Re: Indiana-Kentucky Electric Corporation
Clifty Creek Station's 2018 Annual Landfill Inspection

**Reference: 2018 CCR Rule Inspection
Annual Landfill Inspection
Clifty Creek Generating Station
Madison, Indiana**

**2018 CCR Rule Inspection
Clifty Creek Landfill**

Clifty Creek Generating Station
Madison, Indiana
Jefferson County

Figure No. **1**

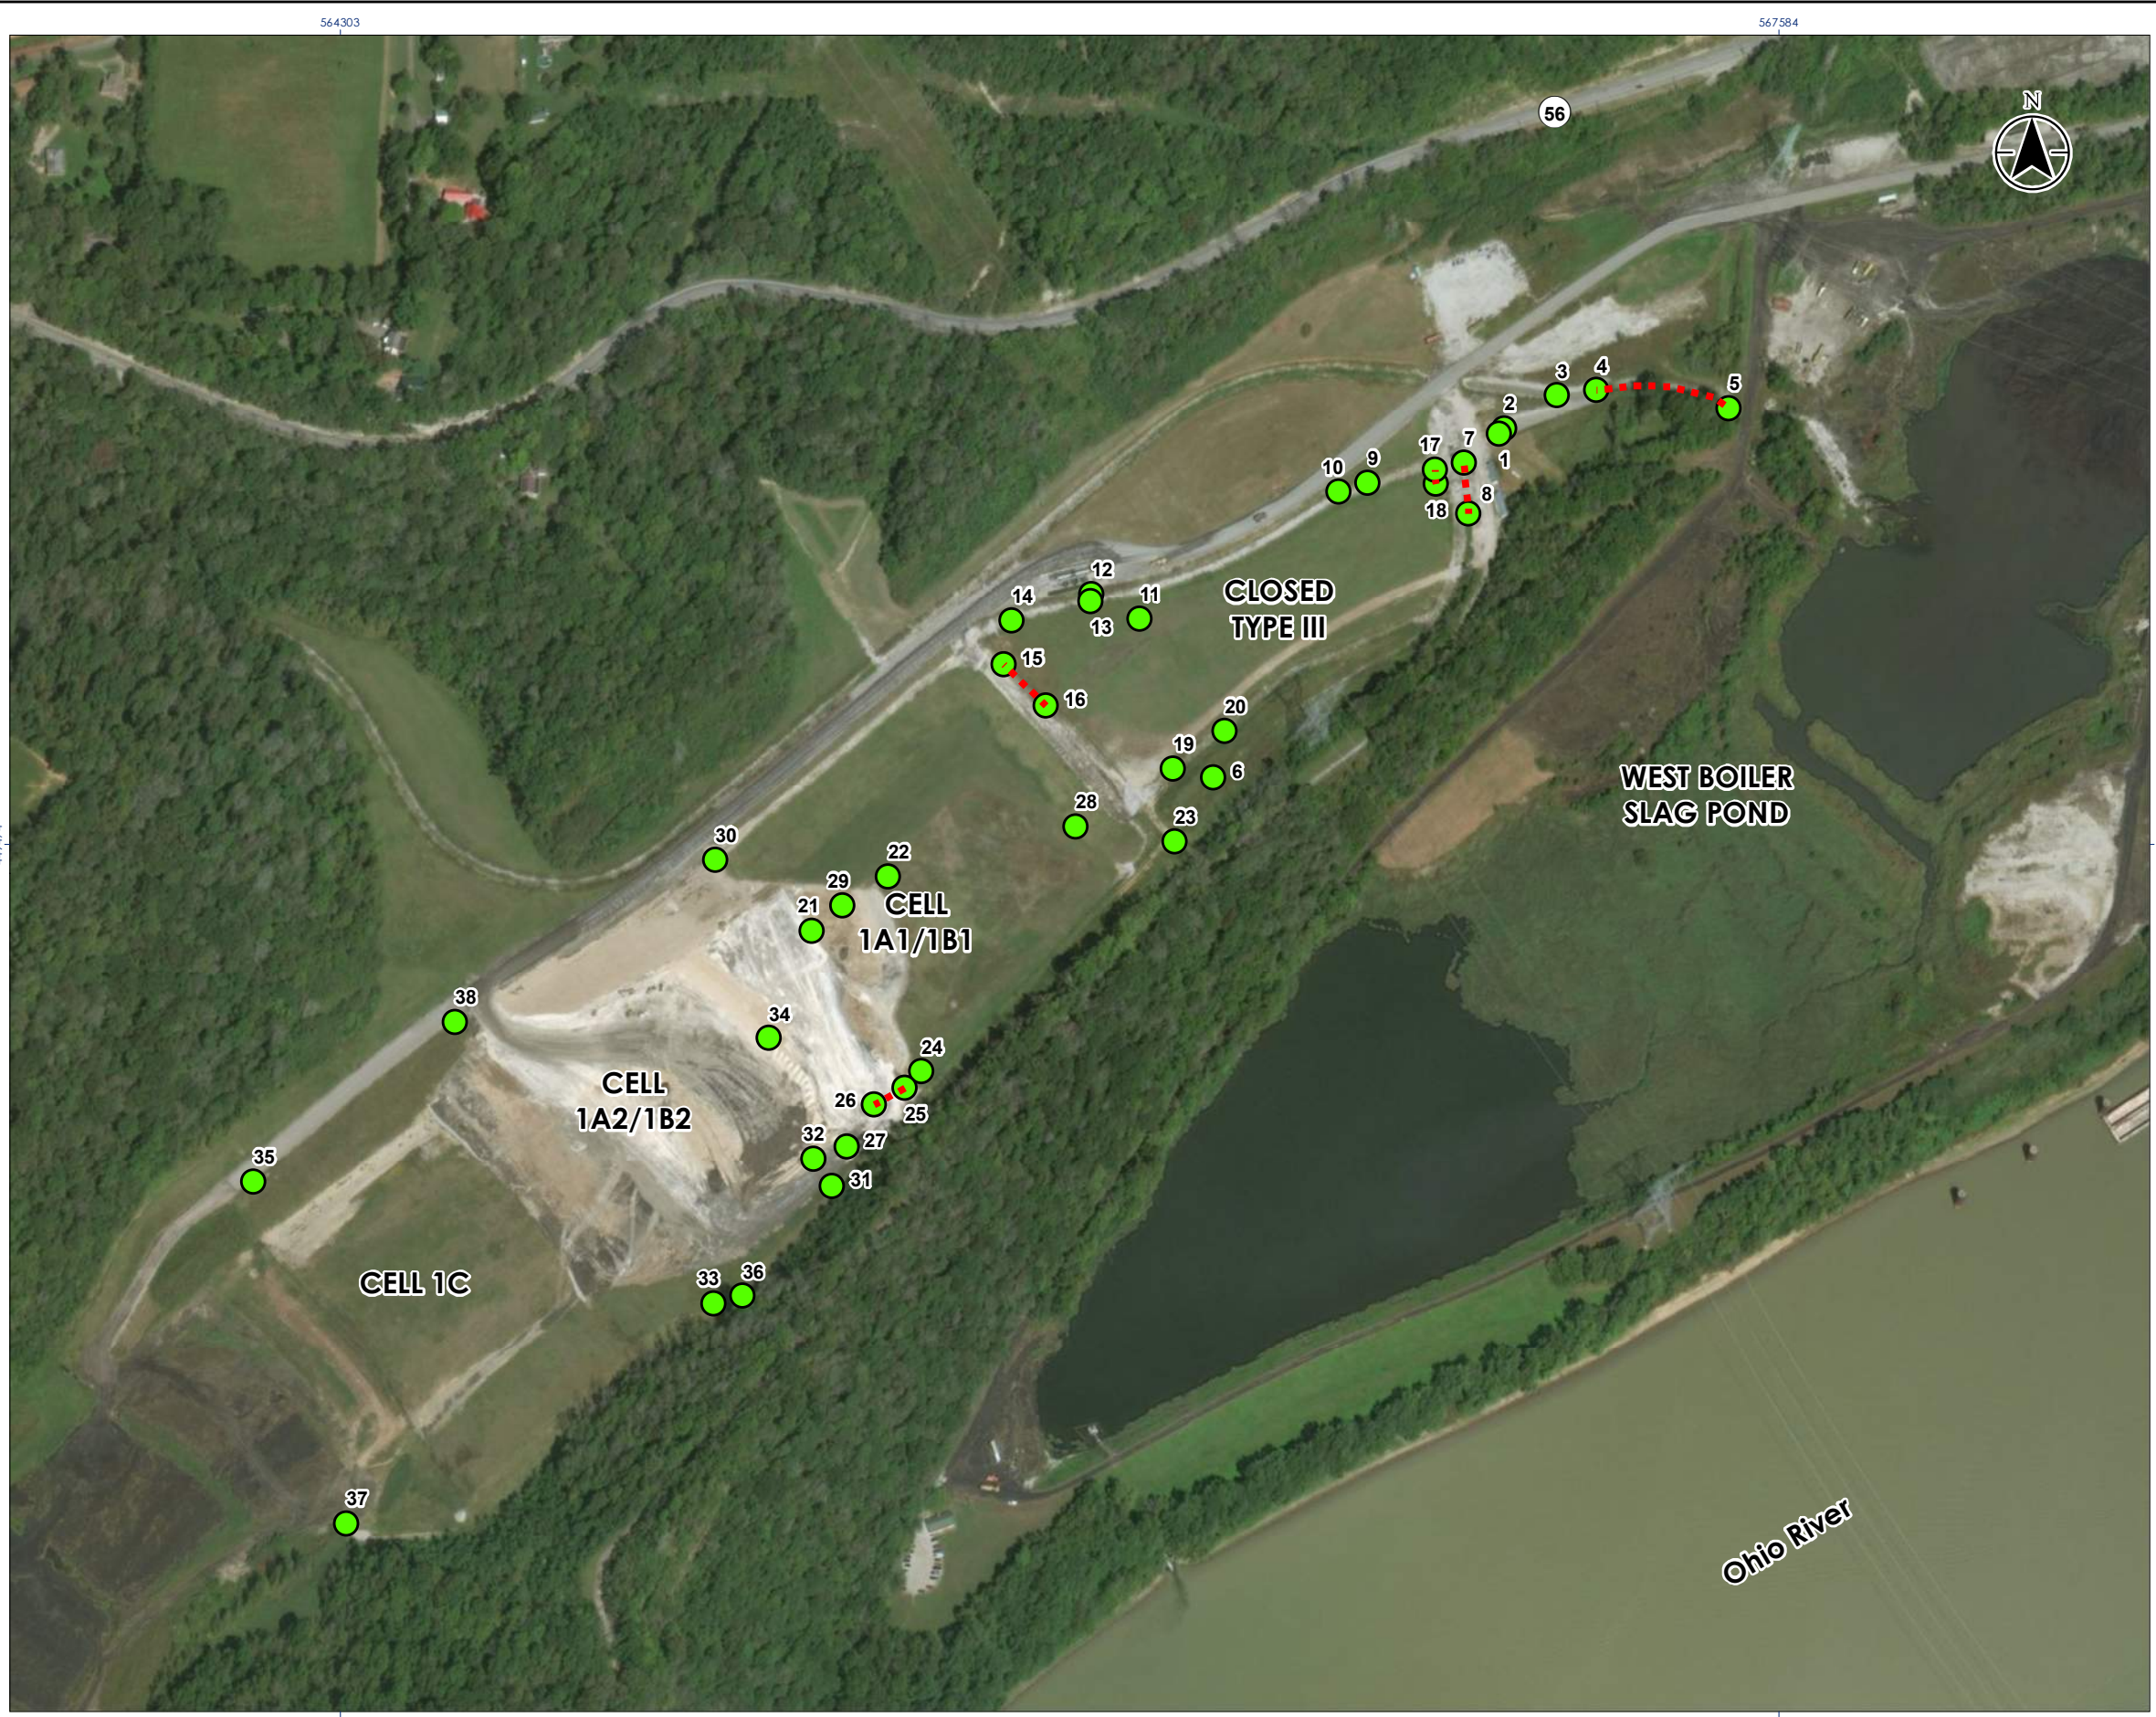
- Cracking, spalling, and deterioration was observed affecting the interior lining of the southernmost of the two culverts passing under the access road on the east end of the closed Type III landfill (Point 1, Appendix A; Photo 1, Appendix B). The deterioration has caused the corrugated metal to be exposed to flow. Both culverts were obscured by vegetation (Point 2, Appendix A; Photo 2, Appendix B).

- The riprap mattress in the north stormwater channel near the haul road was observed to be slightly displaced with bulging and was wavy in appearance (Point 3, Appendix A; Photo 3, Appendix B). This did not appear to impact functionality.

- Dense grassy vegetation obscured visual inspection of the southern surface/storm water channel (Point 6, Appendix A; Photo 6, Appendix B). The western point is marked in Appendix A. Vegetation extends to the road crossing for the Type III landfill near the temporary construction trailer area.

The vegetation density and height has increased since the 2017 inspection, but does not appear to impede flow (Points 7 to 8, Appendix A; Photo 8, Appendix B).

- Vegetation was sparse in a bare area (approximately 4 feet wide by 30 feet long) along the north side of the final grade surface/storm water channel adjacent to the riprap (Point 9, Appendix A; Photo 9, Appendix B). This appeared to be in the same condition as observed the previous two annual CCR Rule inspections.

- A potential slough was observed along the south side of the haul road at the toe of slope toward the northeast corner of the Type III landfill (Point 10, Appendix A; Photo 10, Appendix B). The scarp appeared to be semi-circular, approximately 15-20 feet in diameter. It did not appear to impact the integrity of the haul road. The 2017 photo is included due to denser vegetation during the 2018 site visit.

- An unmarked one-inch PVC standpipe appears to mark the end of a four-inch PVC pipe on the Type III cover (Point 11, Appendix A; Photo 11, Appendix B).

- An erosion rill (approximately 2.5 feet wide by 1.5 feet deep) has formed around the utility pole at the western edge of the truck wash area (Point 12, Appendix A; Photo 12, Appendix B).

- The drainage pipe from the truck wash area into the northern final grade storm/surface water channel on the Type III landfill appeared to be partially obstructed by sediment (Point 13, Appendix A; Photo 13, Appendix B).

- A bare area was noted in the northern final grade surface/storm water channel bed west of the truck wash and downstream of the landfill's check dams (Point 14, Appendix A; Photo 14, Appendix B).

- A bare area was noted along the western edge of the Type III landfill cap (Points 15 to 16, Appendix A; Photo 15, Appendix B).
- The Type III landfill cap appears uniform, mowed, and maintained (Photo 16, Appendix B).

- There was a seep approximately 15 feet north of the northern leachate pipe outlet. The seep was at approximately the same elevation as the invert of the pipe, and consisted of standing water with a sheen and exposed geotextile fabric (Point 17, Appendix A; Photo 20, Appendix B).

- A sheen was seen above and beside the southern leachate pipe headwall (Point 18, Appendix A; Photo 20, Appendix B).
- Sediment was noted in the final grade southern surface/storm water channel (Point 19, Appendix A; Photo 21, Appendix B).

- One four-foot-tall, two-inch-diameter evergreen is present in the final grade southern surface/storm water channel (Point 20, Appendix A).

- The temporary cover vegetation on the top of Subphases 1A1/1B1 (Points 21 and 22, Appendix A; Photos 22 and 23, Appendix B) was generally in one of two conditions: 1.5 feet or taller grasses that were typically laying down, or 4 feet or taller brushy vegetation. The dense vegetation obscured a visual inspection of the slopes for erosion rills. The slopes appeared fairly uniform and unchanged from previous inspections. Additional grading may be needed to prepare the slopes prior to final cover placement.

- Several bare or rocky areas were observed on the temporary cover slopes of Subphases 1A2/1B2. Several erosion rills were observed in the grassed areas downslope from the rocky/bare areas. These bare areas and rills were located as Points 23 through 30 in Appendix A. The edges of a large area of rocky, minimally vegetated temporary cover near the top of the slope was located with Point 31 in Appendix A. Photos 24 through 27 in Appendix B represent typical areas of thin vegetation, erosion rills/gullies, and rocky cover.

- Portions of the landfill near the active cell had recent temporary cover placement and were vegetated at the beginning of this winter season (Point 38, Appendix A; Photo 28, Appendix B).

- The temporary storm water channel along the southern edge of the landfill was riprap-lined and maintained (Point 36, Appendix A; Photo 32, Appendix B).

- The leachate pipe appeared unrestricted and actively flowing. Vegetation was maintained around the headwall to allow visual observation (Point 37, Appendix A; Photo 33, Appendix B).

- Conduct field surveys to measure current topography and compare to design geometry. Regrade surface as needed to conform to design. Areas near permitted CCR grades are recommended to be capped, closed, and vegetated (Subphases 1A1, 1B1, 1A2, and 1B2).
- Monitor seeps from the northeast corner of the Type III landfill. Consider ways to segregate and reduce the various source of flows into the eastward stormwater and leachate collection channel.

- Maintain the vegetation along the exterior slopes and within the surface drainage channels to facilitate inspections by removing taller weeds and woody vegetation or reestablishing vegetation as needed. Particular attention should be given to the taller brushy vegetation on the top of the landfill and the rocky, bare areas on the northern slope. Temporary cover should be monitored and maintained as gradation specifications deviate from the final cover requirements.

- Remove excess vegetation from drainage channels, pipe inlets, and outlets. Flow was visible at the pipes observed by Stantec during the December site visit.

- Continue to repair erosion features, reestablish vegetation, and monitor in future inspections.
- Continue to monitor the surface water channel headwalls and culverts east of the landfill. Repair as needed.

- Monitor the integrity of the exposed corrugated metal in the southernmost of the culverts near the temporary construction trailers. If needed, remediation of the culvert should be considered to re-establish an internal liner for the pipe.

- Monitor the slough near the haul road on the north side of the Type III landfill. If the slough progresses toward the haul road and/or truck wash facility, remediation could be considered.

- Clean out sediment from the truck wash surface water drainage pipe outlet/headwall area and the surface water collection pipes.
